A.1 Summary of Field Observations

Submission 12

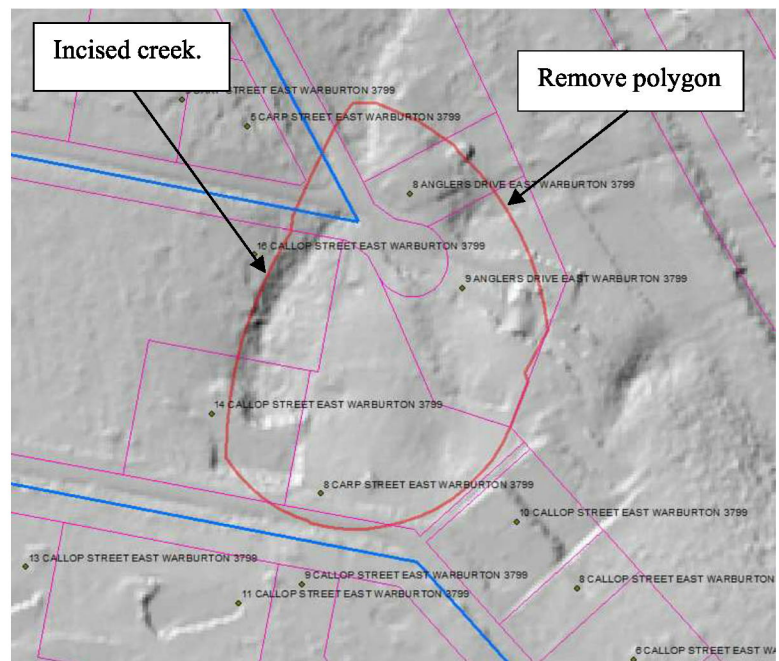
A feature was identified in LiDAR as indicative of a landslide feature. Field visits indicate the feature is likely fluvial, formed by a now abandoned river channel.

Recommend removal of polygon indicating landslide.

Submission 13

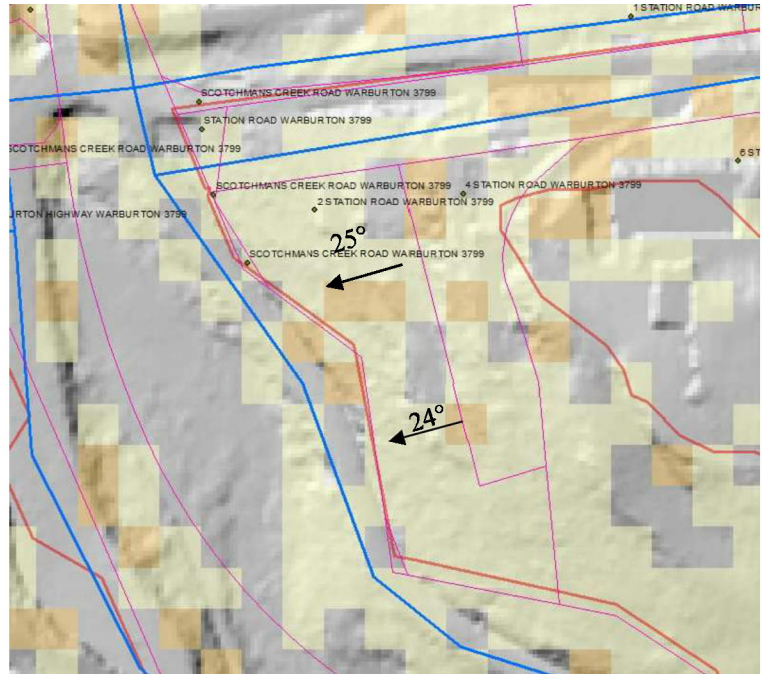
The average slope angle was measured to be 24° to 25° which exceeds the threshold for inclusion. Rock outcrops in Station Street and along Glenbrook Road were assessed and found to be consistent with geological map indications.

No change to mapping recommended.

Submission 16

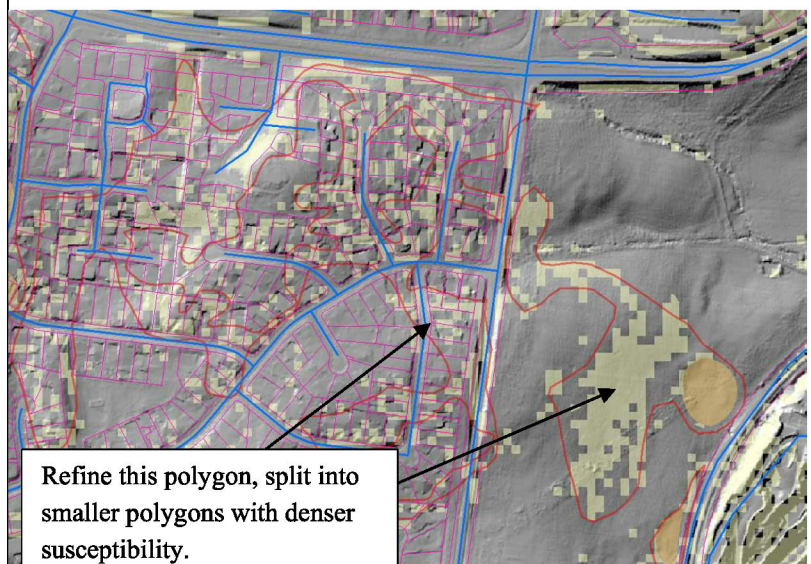
Natural slope angles in the areas with denser mapped susceptibility were typically 9° or more, above the threshold for inclusion and within less dense areas typically less than 9° putting the two polygons in this area on the cusp of inclusion.

The area is heavily impacted by earthworks.

We recommend refining the polygon in this area by mapping at a finer scale and splitting it into smaller polygons encompassing denser mapped susceptibility.

Submission 20

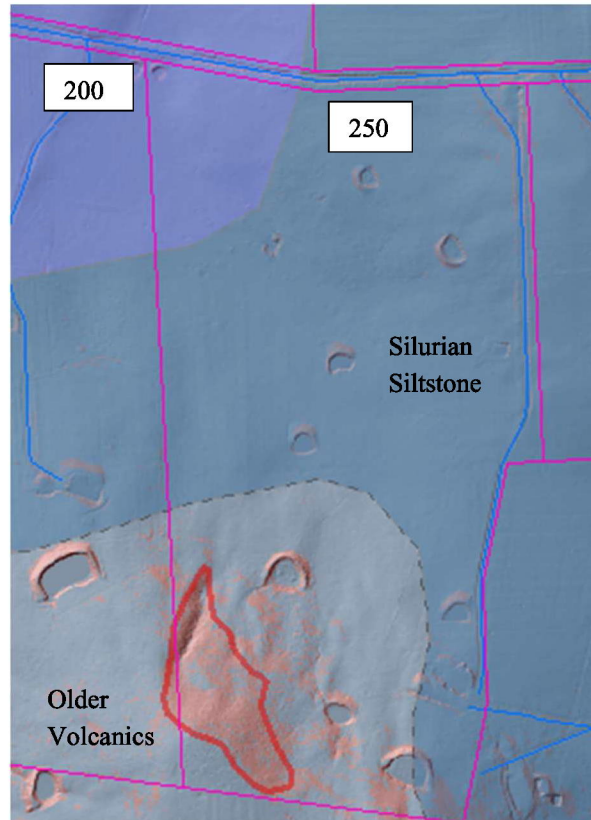
The area identified as susceptible generally has a slope angle of $> 9^\circ$ (areas in red in adjacent figure). Geomorphological desktop mapping and field observations nearby indicate that the ridge to the south and adjacent slopes, including the susceptible area, is underlain by a surface layer of Older Volcanics, which has been assessed to be susceptible to instability where slope angles are above 9° . The desktop mapping shows geomorphological signs of slope instability having occurred in the past on this slope.

Submission 25

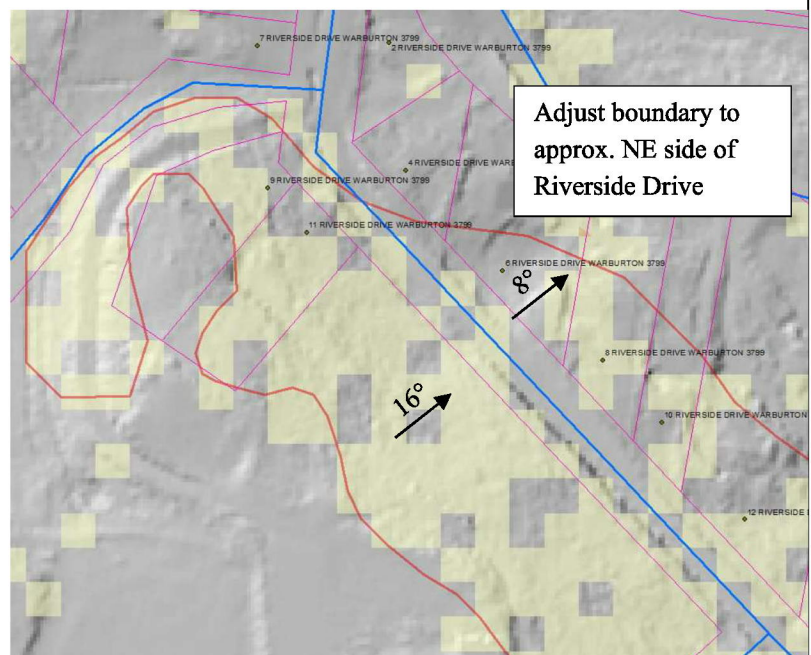
The natural slope on the north east side of Riverside Drive shallows to about 8° , below the 11° threshold. The mapped susceptible areas shown northeast of Riverside Drive are related to earthworks.

Recommend adjusting the northeast EMO boundary in this area 20 m to 30 m towards Riverside Drive.

Submission 30

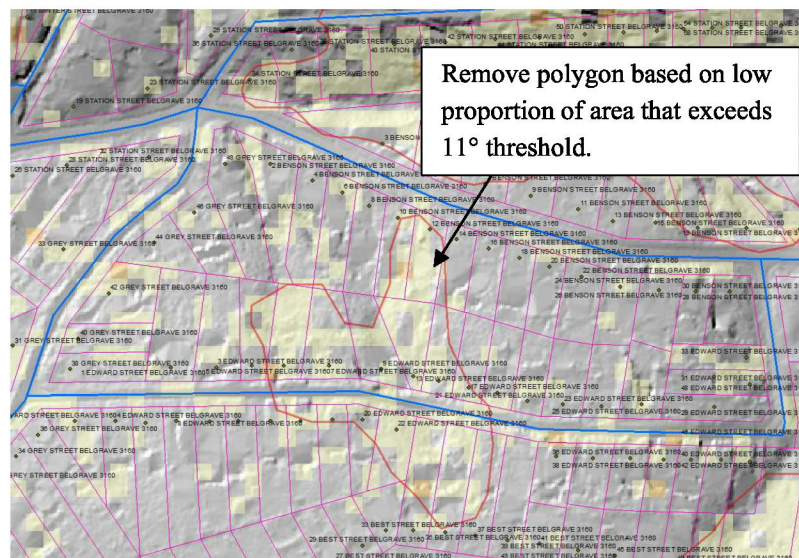
The mapped susceptible area relates to what appears to be past filling on the area.

Recommend removal of the polygon shown on the basis that the area has a natural slope angle of 10° to 12° . Although in some parts of this polygon the natural slope angle exceeds the criteria for inclusion, these areas are too small to be delineated as a separate polygon. Recommend removal of this polygon.

Submission 33

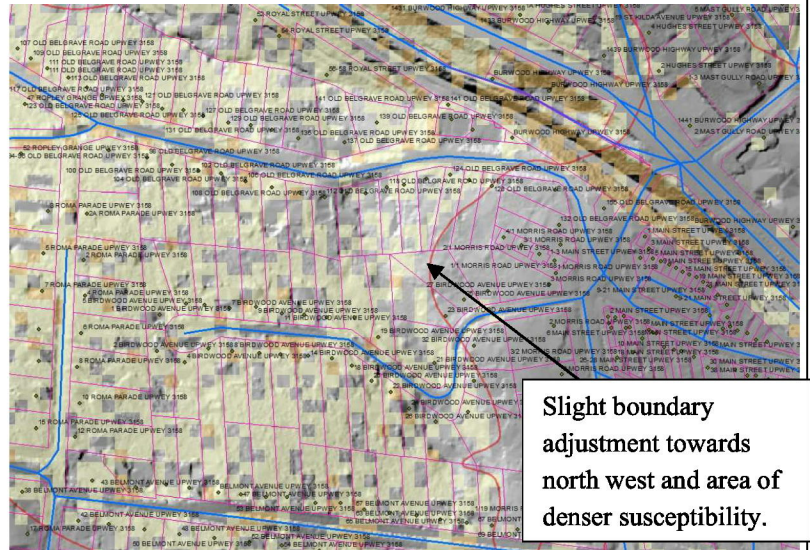
There is a gully through this area which meets the criteria for inclusion and some properties have placed fill up to the edge of the gully. The areas of less dense mapped susceptibility are related to earthworks.

Recommend a slight boundary adjustment through here to shift the boundary closer to the areas of denser mapped susceptibility.

Submission 39

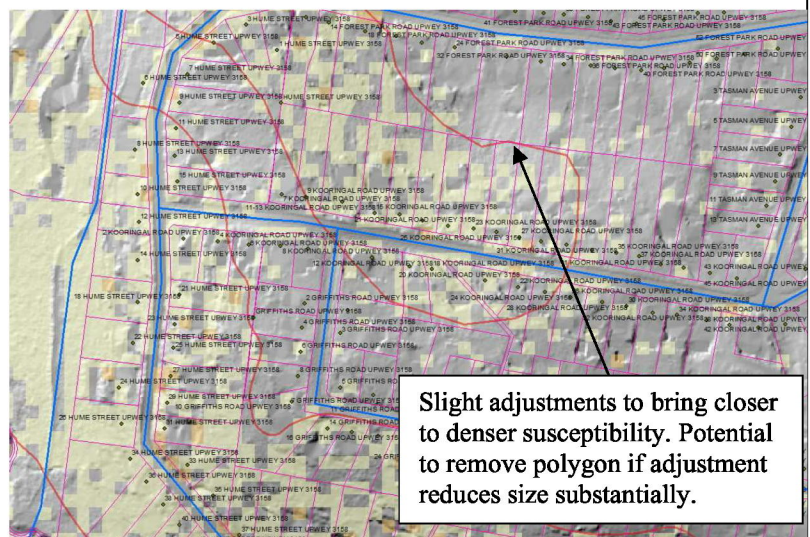
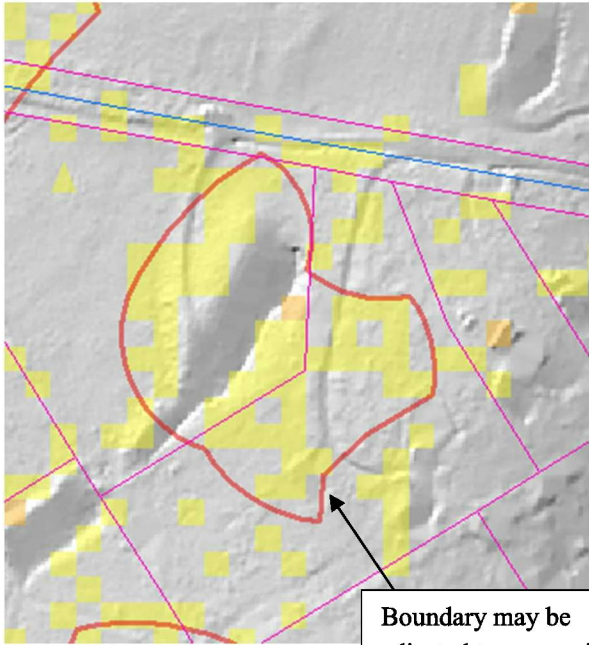
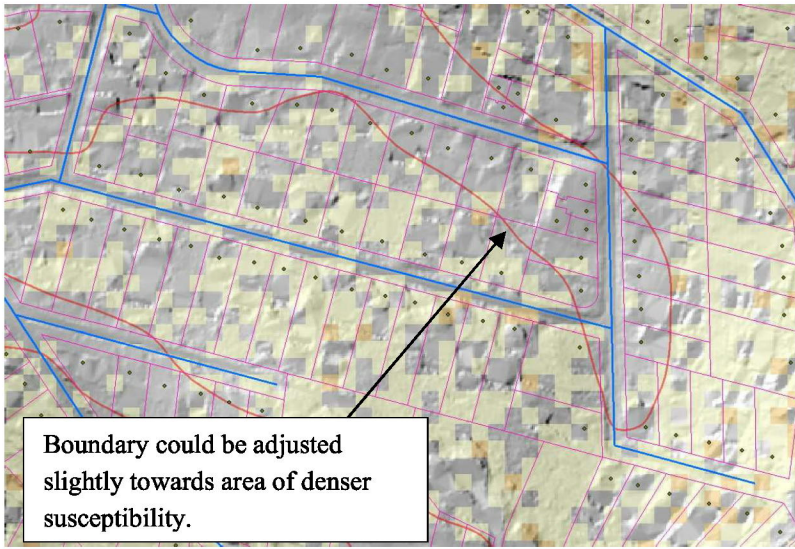
Natural slopes were measured at 11° to 12° through this area, including on properties south of Koorlingal Road in the vicinity of 16 Koorlingal which is marginal for inclusion based on a threshold of >11°. The mapped susceptibility is also influenced by earthworks. Given the marginal slope angle, there is scope for a slight adjustment of the boundary of this polygon, in the order of 20 m to shift it closer to areas of denser mapped susceptibility.

Submission 47

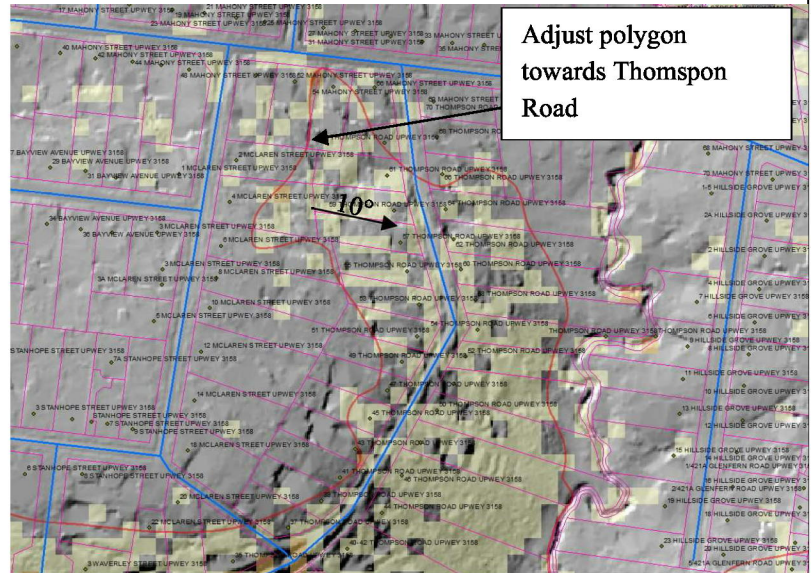
The natural slope angle was measured at 10° in areas to the west of Thompson Road, with the areas indicated as susceptible influenced by earthworks. Criteria for inclusion is 11° .

Recommend adjustment of this polygon to move the western boundary further to the East.

Submission 49

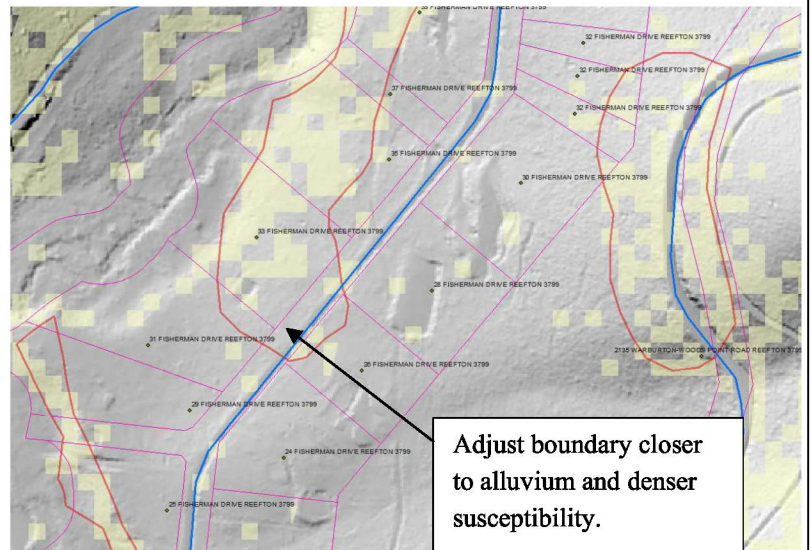
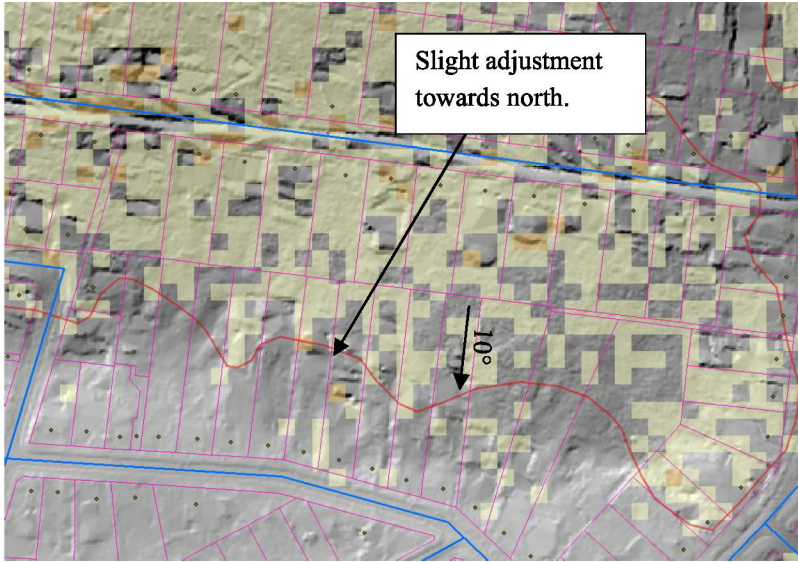
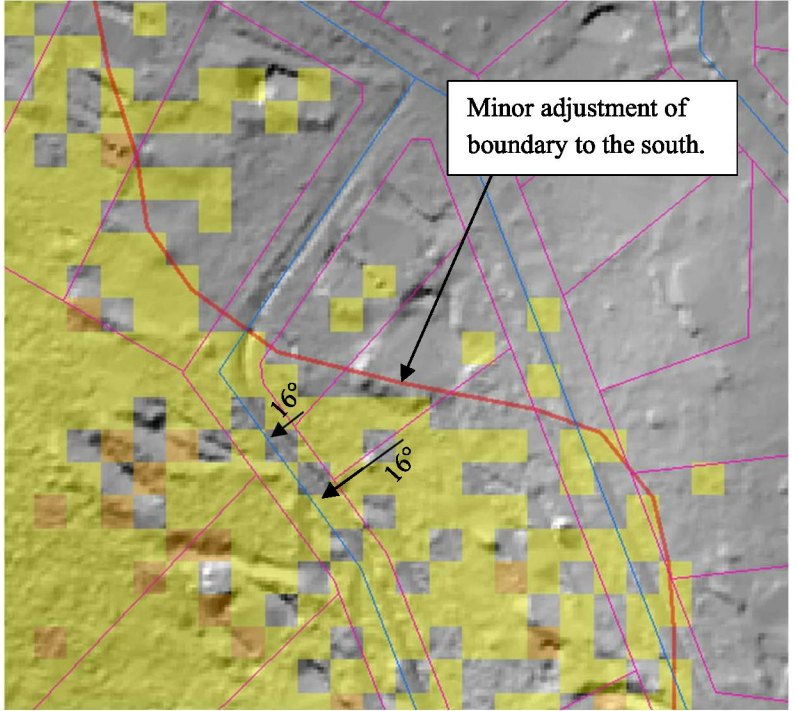
Note that this site was not visited, however LiDAR allows identification of the geological boundary of alluvium through this area, which differs from geological map indications. There is therefore a basis to adjust the geological boundary and adjust the EMO extent accordingly.

Submission 56

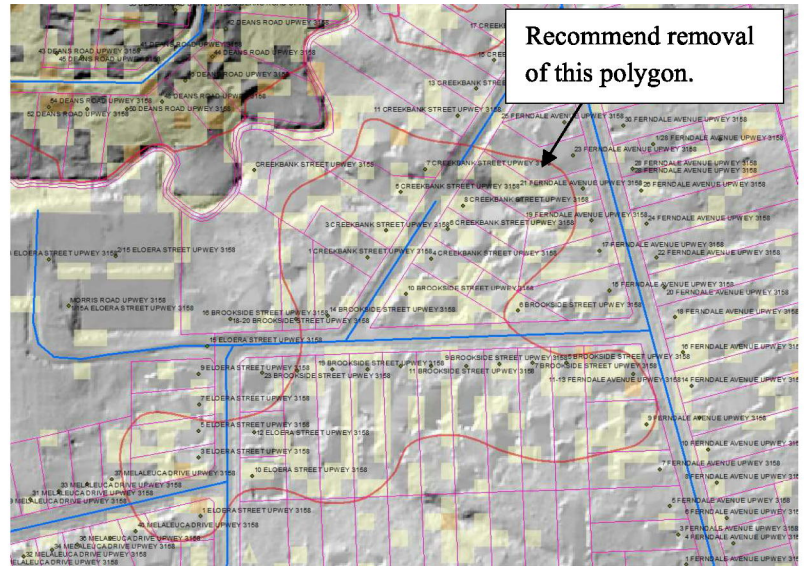
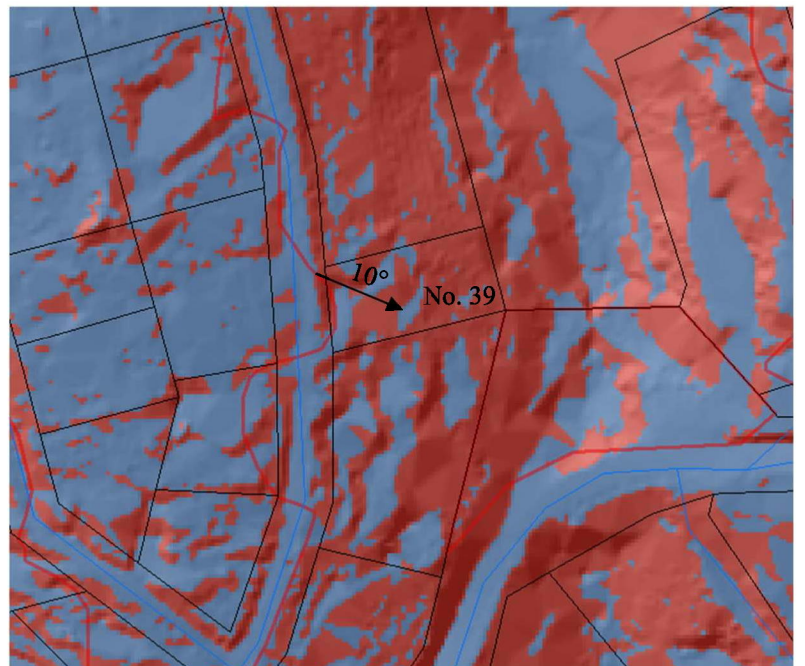
The natural slope angle of the polygon in this area varies through this area between 10° and 11°, but overall is around 11° or marginally lower, noting 11° is the threshold for inclusion.

Recommend removal of this polygon.

Submission 59

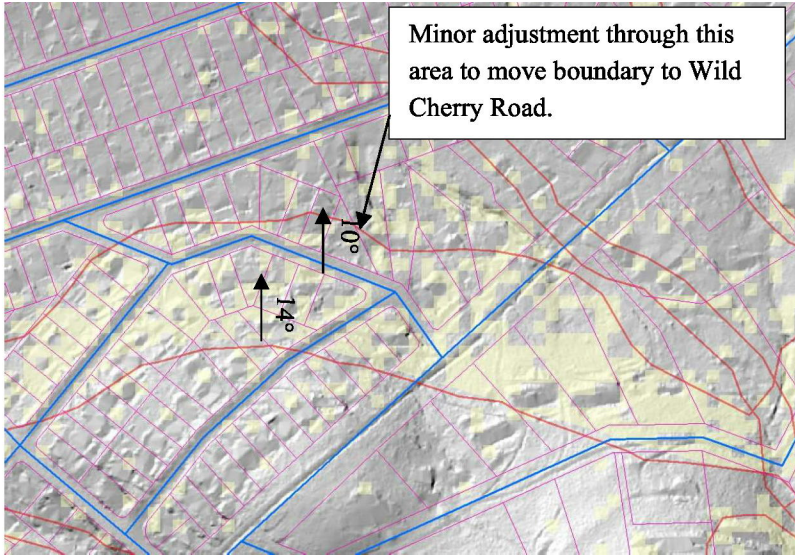
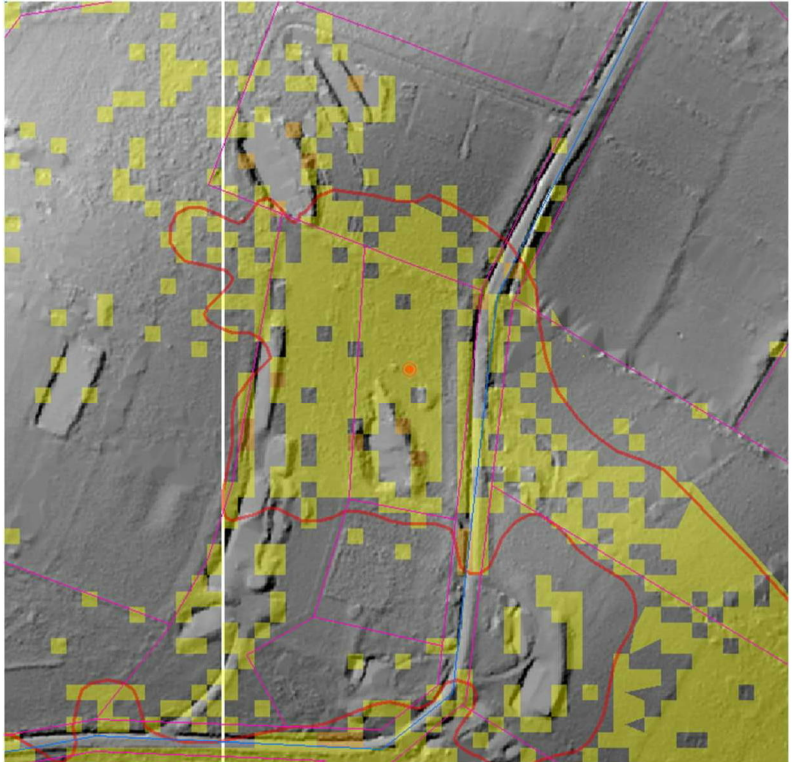
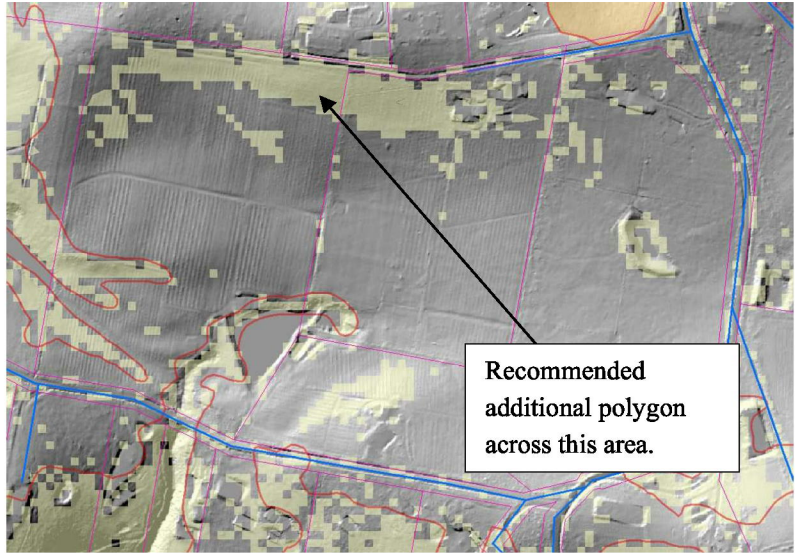
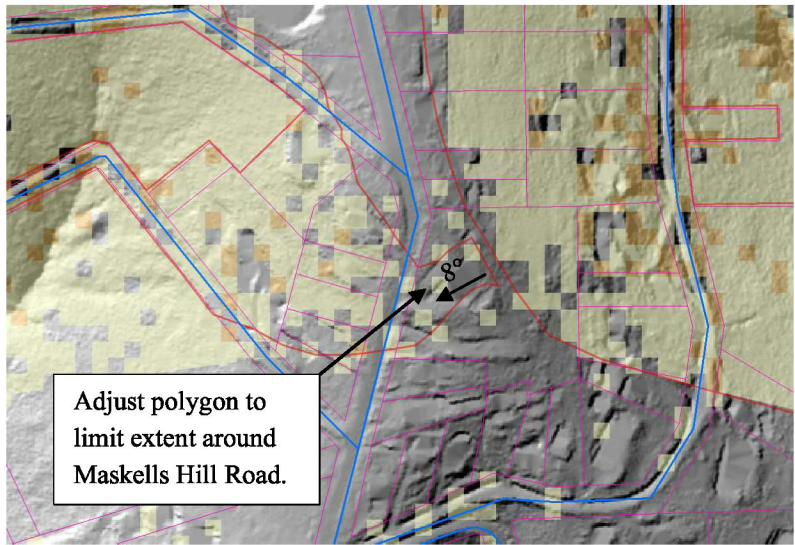
Natural slope angles measured at 10° in the western part of the site, in the vicinity of the house and driveway. Slope angles in the eastern part of the site are generally steeper and above 11° (areas in red in adjacent figure) based on LiDAR elevation data, which is the threshold for inclusion in the EMO where underlain by Ferny Creek Rhyodacite. Areas below the threshold are generally benched earthworks areas for the house and driveway.

Some minor adjustment of the EMO boundaries may be possible to capture denser mapped susceptibility areas but part of the property would be included in the proposed EMO.

Submission 73

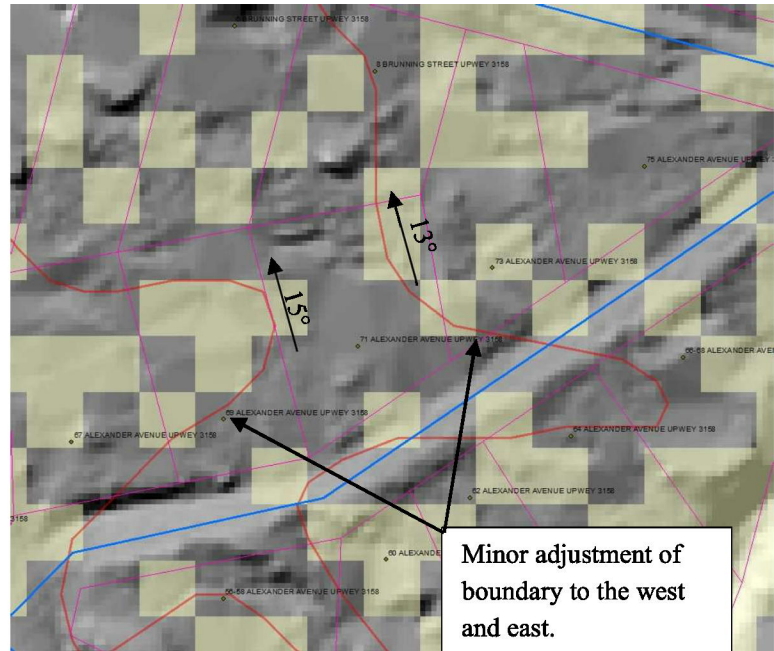
Natural slope angles are 13° to 15° adjacent to the house. Which exceeds the threshold for inclusion in the EMO.

Mapping at a finer scale and some minor adjustment of the proposed EMO boundaries may be possible to better capture denser mapped susceptibility areas.
